**RFP NO. 872
ADDENDUM NO. 2**

Subject: RFP No. 872: Foreign Object Debris (FOD) Detection System

**Attachment No. 1
Proposed Questions and
Associated County Responses**

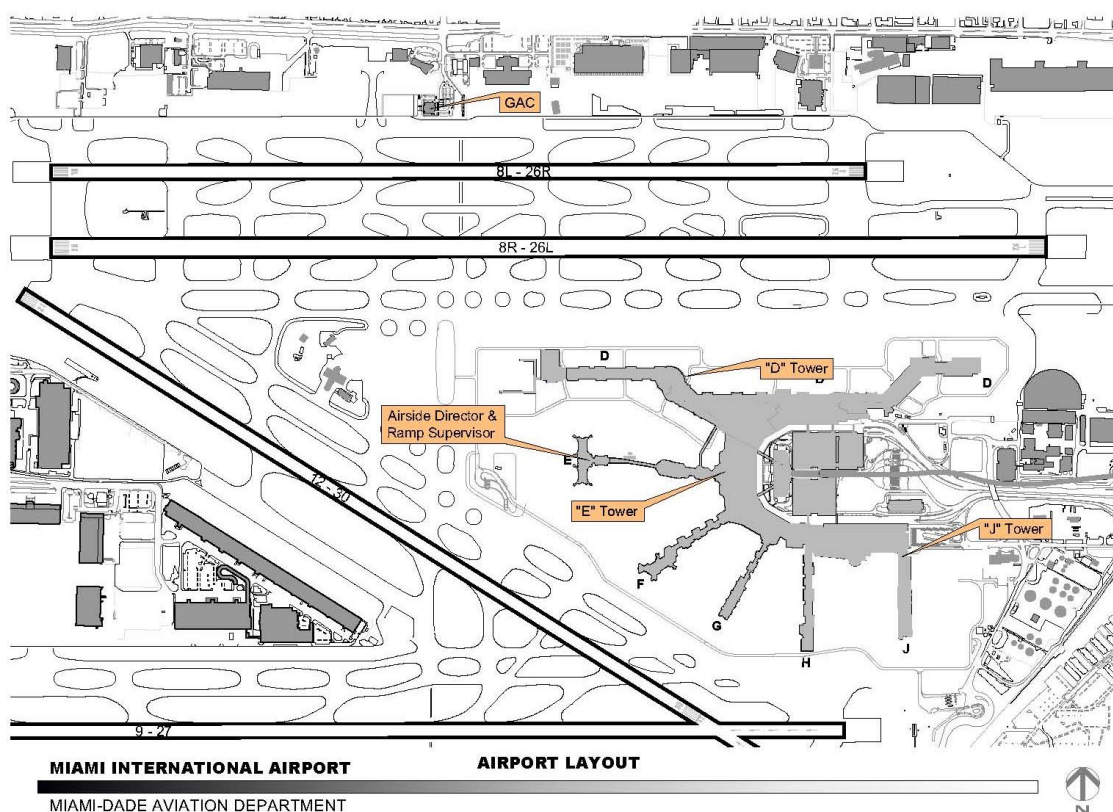
- Q 43.** Is there any constrain to install an approximately 16.4ft (5m) high iFerret tower above runway center line at location mark N1 (which is to be situated behind the ILS and about 400 ft from the runway center line) for iFerret Electro-Optics Sensor Mounting (picture below)?

- Q 45.** Is there any constrain to install an approximately 36ft (11m) high iFerret tower above runway center line at location mark at N1 for iFerret Electro-Optics Sensor Mounting (picture below)?

- Q 46.** Is there any constrain to install a 33ft (10m) high iFerret tower above runway center line at location mark at N2, N3, N4 for iFerret Sensor Mounting (see figure above)?

- A 43.** *The structure as shown penetrates the FAR Part 77 surfaces and would require FAA review.*

- A 45.** *The structure as shown penetrates the FAR Part 77 surfaces and would require FAA review and approval.*

- A 46.** *A tower installed within these locations may conflict with a Taxiway Object Free Area and would require FAA review and approval.*

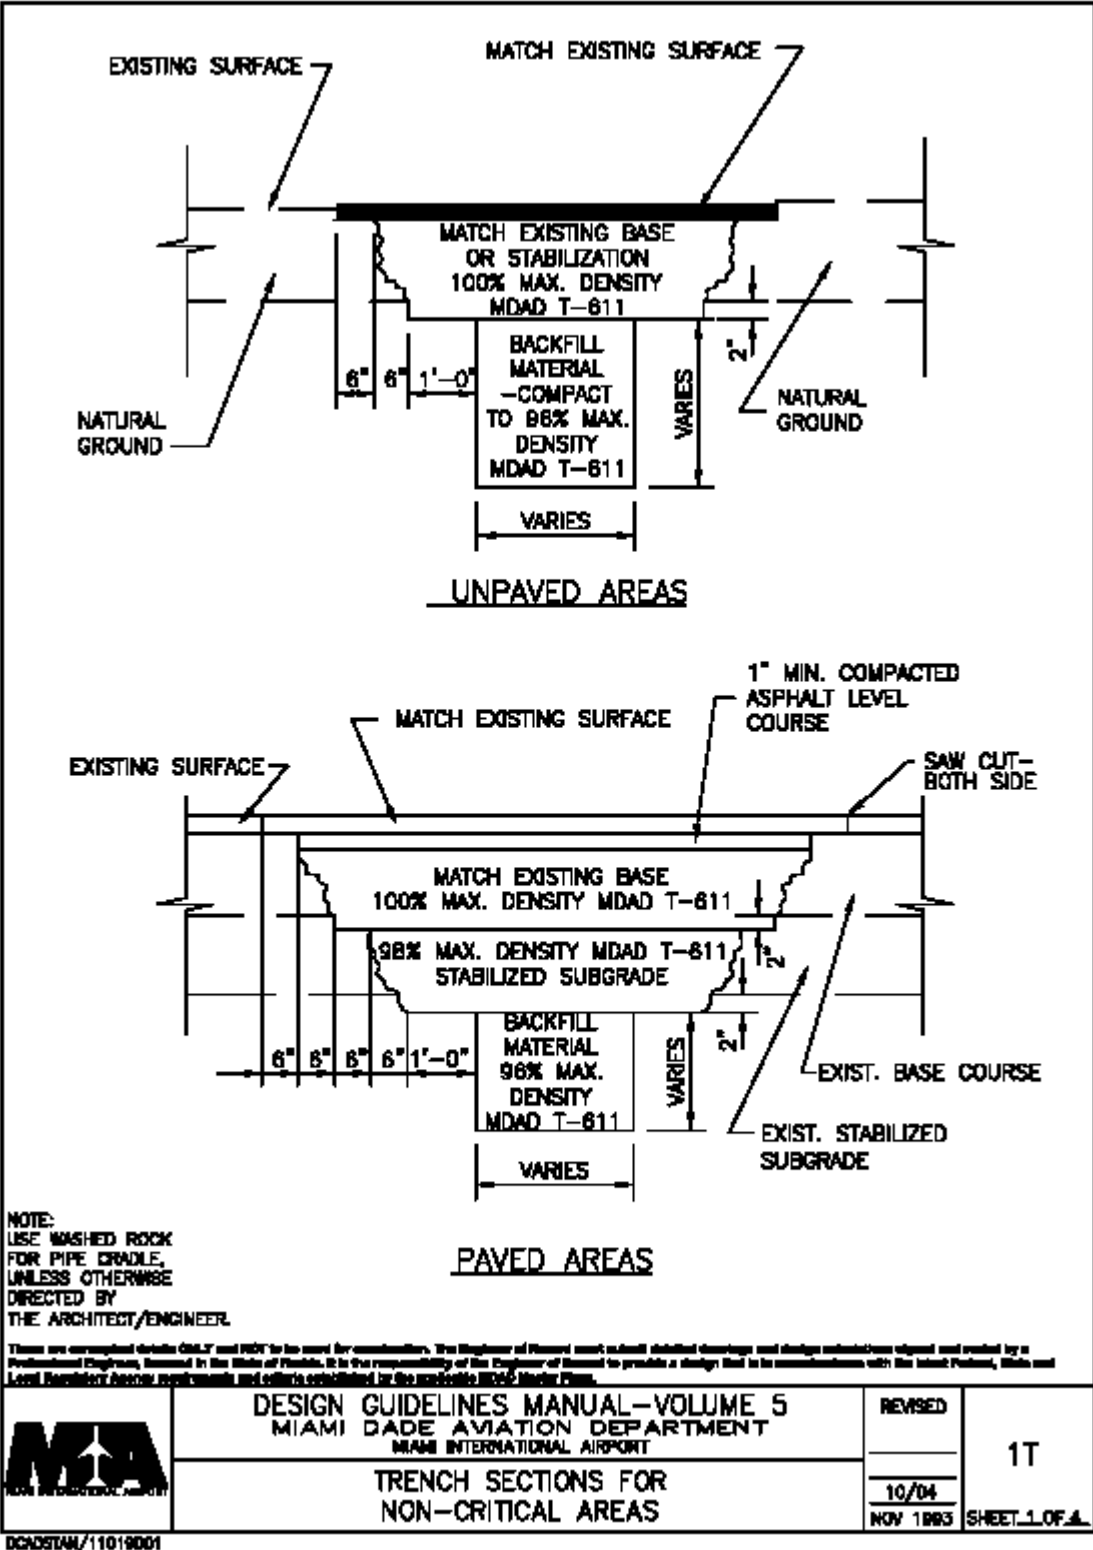
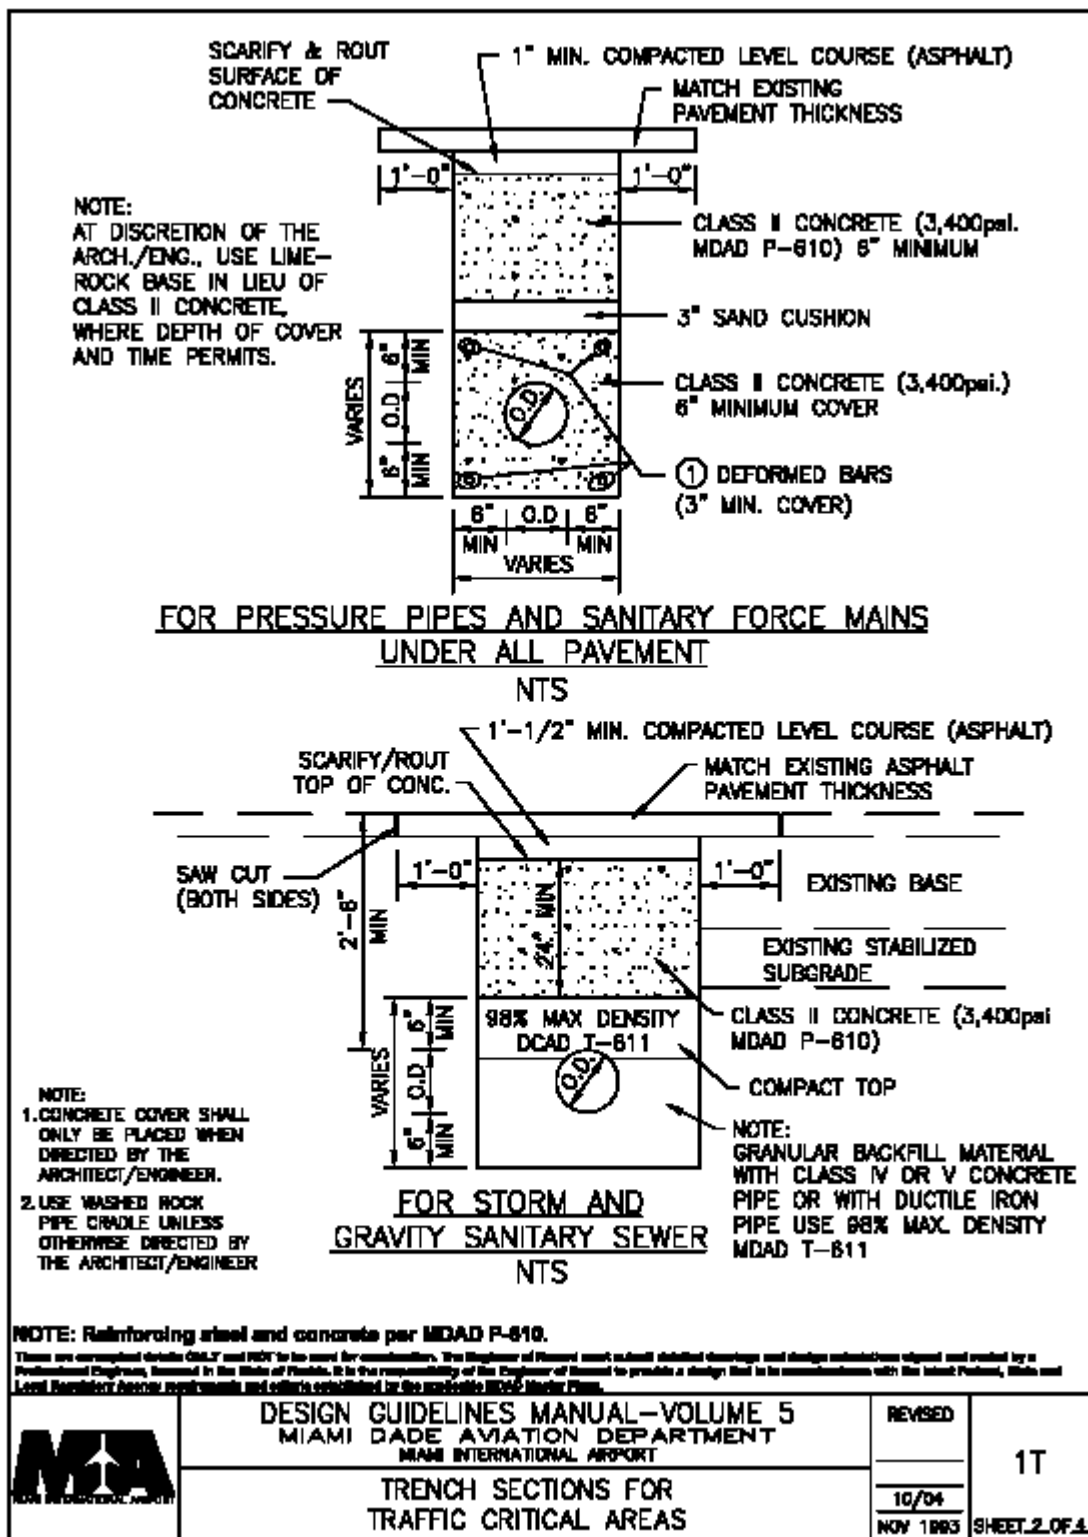
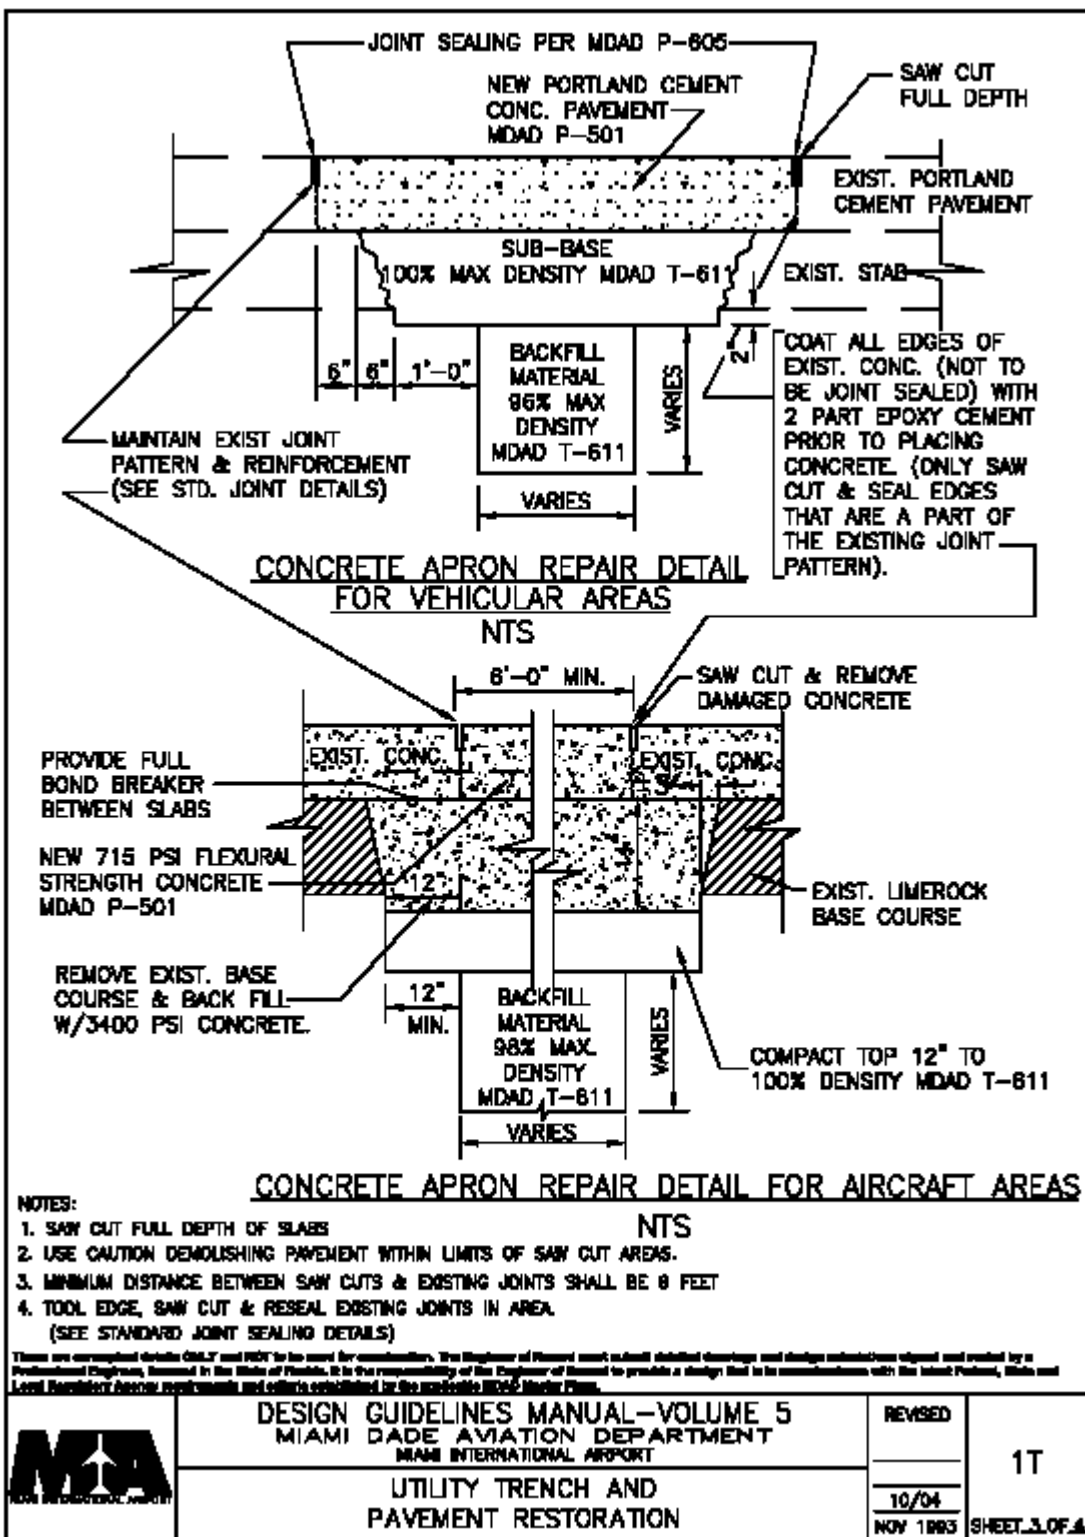
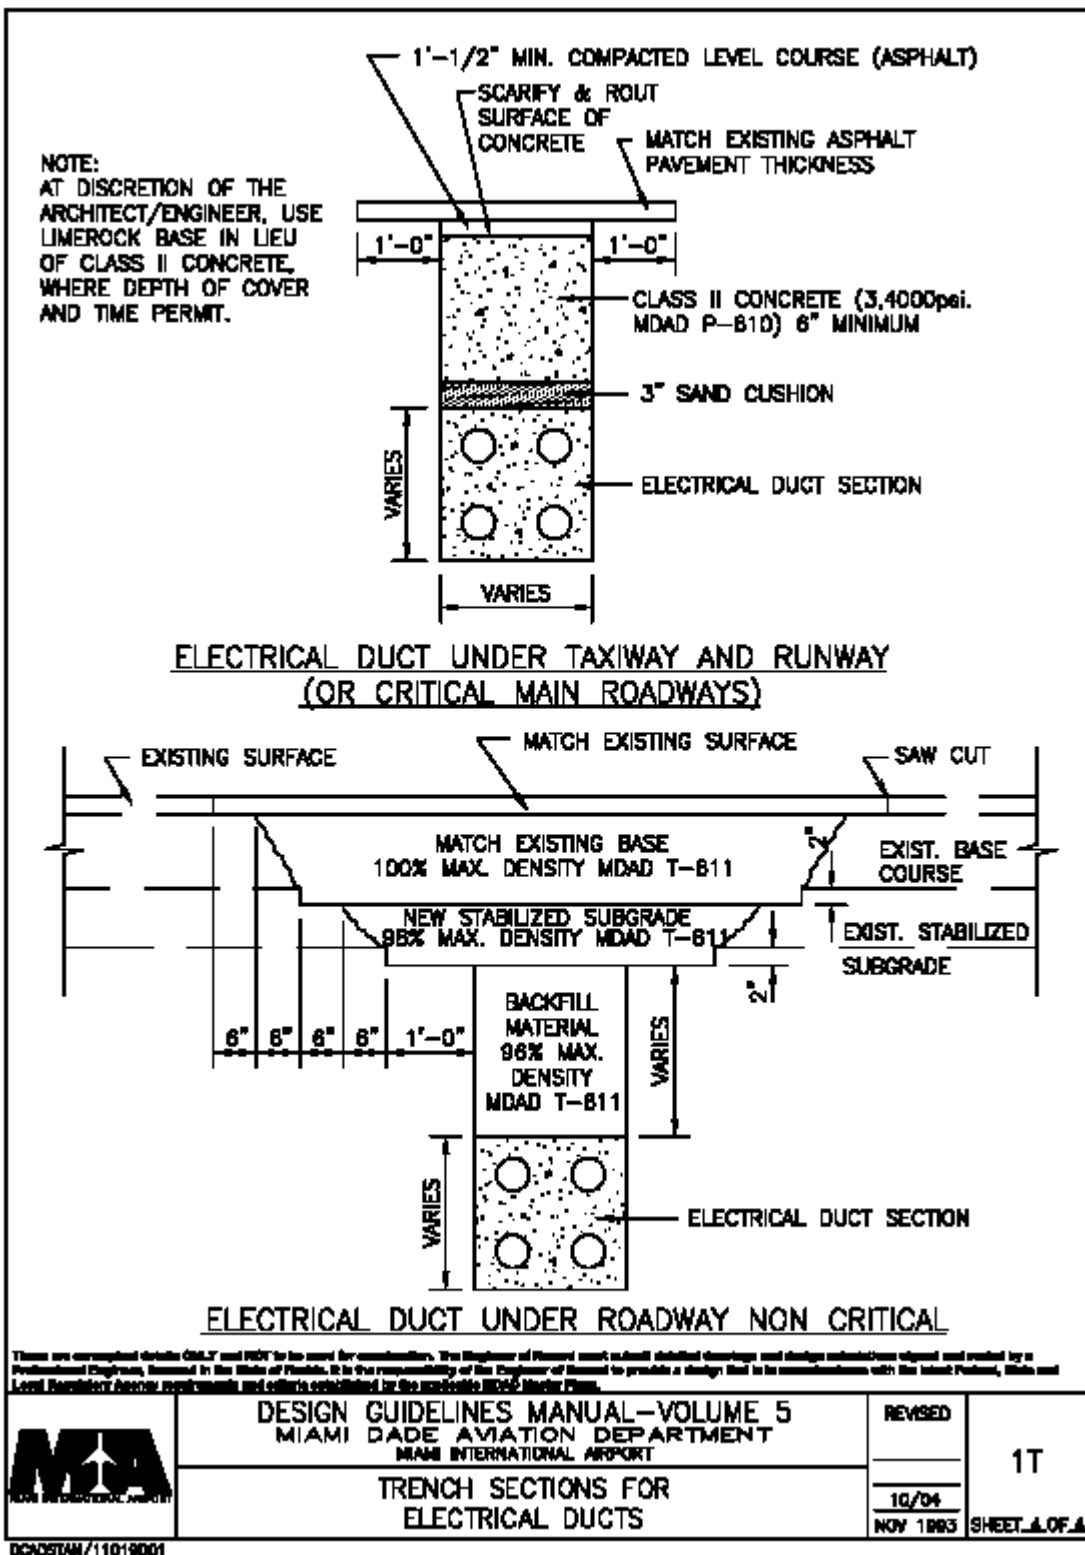
- Q 61.** Please provide a detail diagram for repair of a sawcut in the shoulder area?

A 61. *The MDAD Standard Details for pavement restoration associated with utility trenches are below. The selection of the appropriate repair is predicated on the location, type of traffic (aircraft or vehicular), trench width, type of utility and pavement (flexible or rigid). In flexible (asphalt) pavement, the saw cut is normally full depth; the subsequent restoration will require tack coating along the edge of the sawcut and the new pavement matching the existing asphalt thickness. Depending on the trench width, concrete may also be cast to the surface, and subsequently milled and overlay with asphalt. It should be noted that MDAD will not allow a sawcut in pavement for the sole purpose of installing direct buried cables.*
